# Biuletyn Techniczny

Numer:	OSB11-04-051
Data:	2 listopada 2011
Wersja:	00

## Cruze J300 – Piszczenie tylnych zacisków hamulcowych

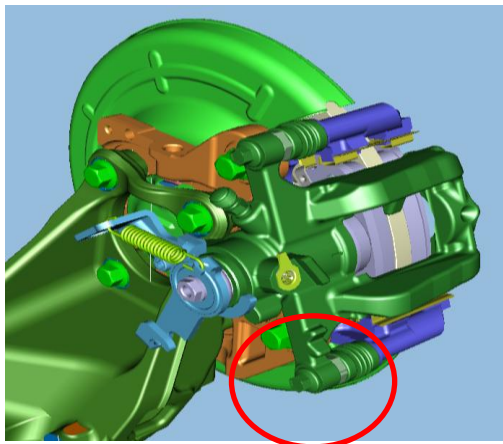
Klienci mogą skarżyć się na piszczenie podczas lekkiego hamowania jadąc do tyłu. Dźwięk ten może być słyszany szczególnie podczas deszczu lub wysokiej wilgotności powietrza.

Zainstalować zestaw tłumików (13337450)

Tłumik (2szt na auto)

Śruba tłumika (2 szt na auto)
